**RE: The Wymont  
4315 Wyoming Blvd NE  
Grading and Drainage Plans  
Engineer's Stamp Date: 01/27/22  
Hydrology File: G19D004**

**RE: The Wymont  
4315 Wyoming Blvd NE  
Grading and Drainage Plans (G19D004)**

Per the correspondence dated December 27, 2021, please find the following responses addressing the comments listed below:

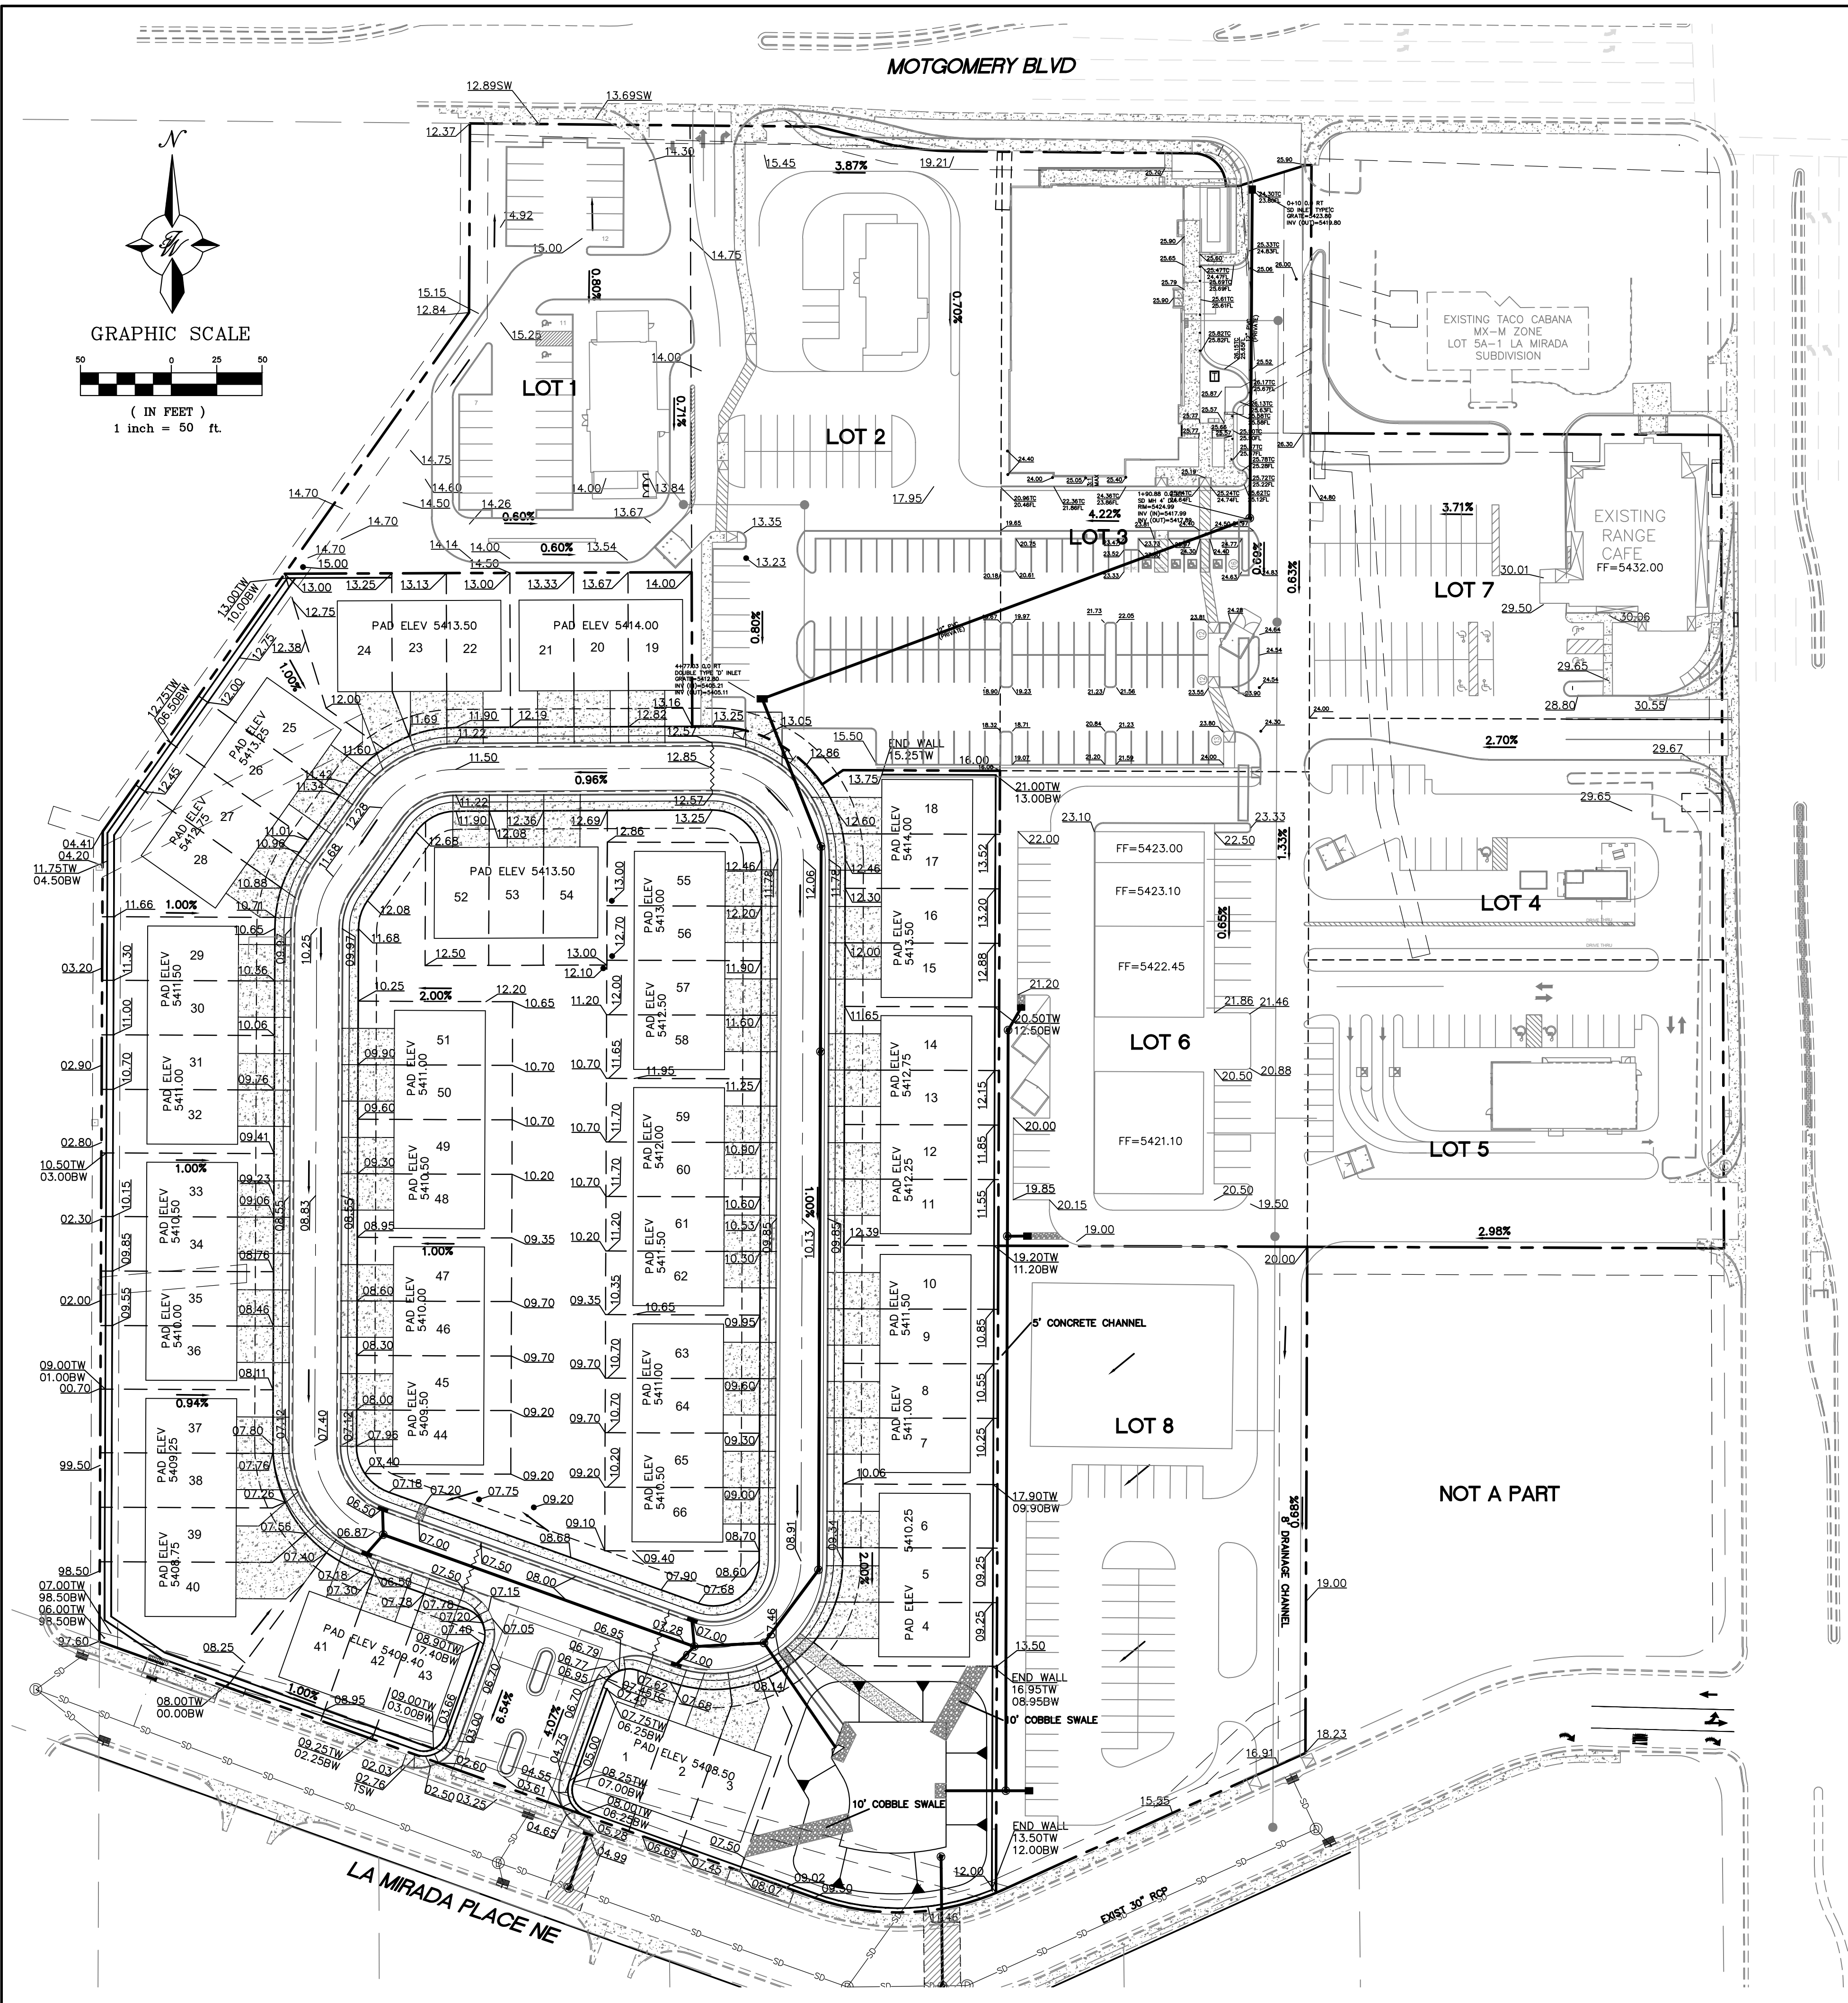
3. GR-1. This is currently very congested and difficult to read. Please, make this sheet just an overall Grading Plan with added pipe sizes, detention pond labeled, proposed contours, and line work with text showing which pipes and grading are to be done under which of the two work orders. **The sheet scale was increased to 1"=30' for better readability.**

4. GR-1. Please add a note, "Side slopes need to be stabilized with Native Grass Seed (per City Spec 1012) with Aggregate Mulch or equal (Must satisfy the "Final Stabilization criteria" CGP 2.2.14.b.)". This is for the water quality pond. **This note was added to the plan**
